UNITED STATES ENVIRONMENTAL PROTECTION AGENCY
REGION 10
OREGON OPERATIONS OFFICE
805 SW Broadway, Suite 500
Portland, Oregon 97205

RE: EPA Recommendations for Data Gaps Evaluations during Development of the Feasibility Study
for the Former Rhone Poulenc - Portland Site

RECOMMENDED DATA GAPS FOR ADDRESSING IN FEASIBILITY STUDY DEVELOPMENT

FIGURE 1 Targeted Deep Groundwater Area

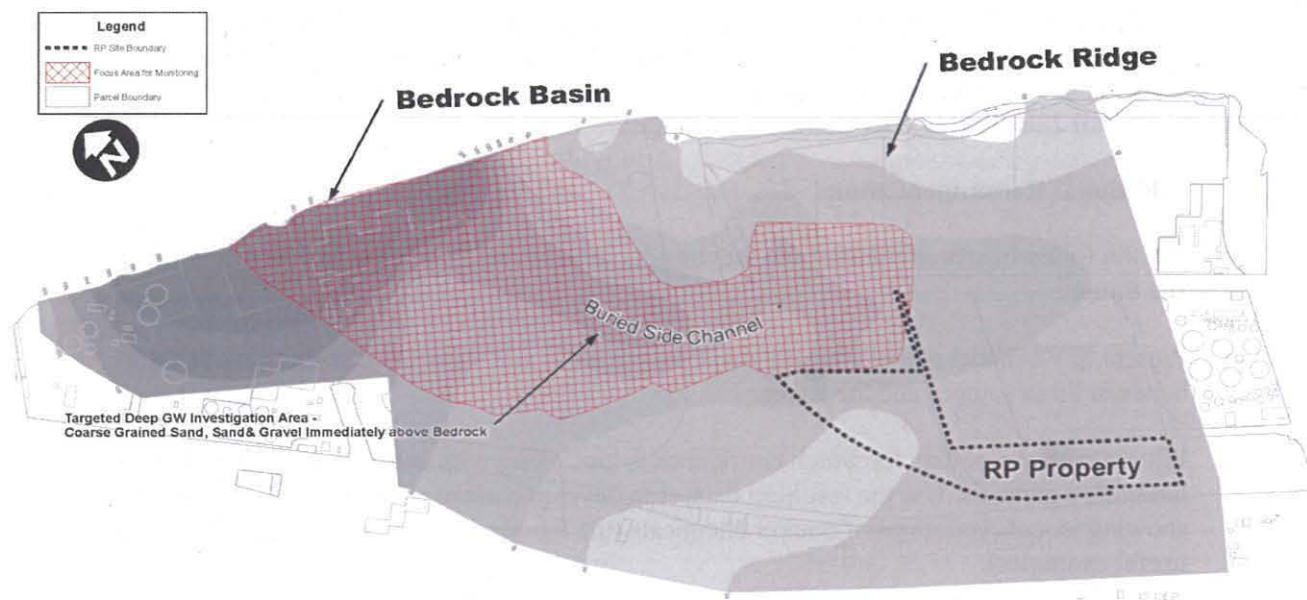
Areas of uncertainty and recommended efforts to reduce remaining uncertainties are summarized in this memorandum. Uncertainty is associated with the limited data for a COCs migration pathway in deep groundwater originating from source areas and with subsequent release to the River. The deep groundwater that may be part of this transport pathway underlies portions of properties north and east of the BNSF railway and along the riverbank as depicted in **Figure 1**. Recommended actions that can be conducted in parallel with the FS phase are listed below.

EPA recommends that as an effort parallel with evaluating remedial alternatives in the FS phase, SLLI develop a groundwater monitoring plan -- for DEQ and EPA review -- that includes sampling of existing monitoring wells and newly installed monitoring wells if deemed necessary that are completed in the coarse sand and/or gravel overlying bedrock in the area shown by red hatching in **Figure 1**. The objective of this sampling plan is to provide current groundwater data to address the presence or absence of COCs and to document concentrations within the alluvial unit and the coarse-grained material overlying bedrock that would, if present, represent a deep groundwater transport pathway from contaminate sources at the former Rhone Poulenc property (i.e., DNAPL/LNAPL area) to the River. In addition, this sampling effort will fill the data gap for COCs in this coarse-grained layer and provide information to support future evaluations of protectiveness and potential response actions' performance.
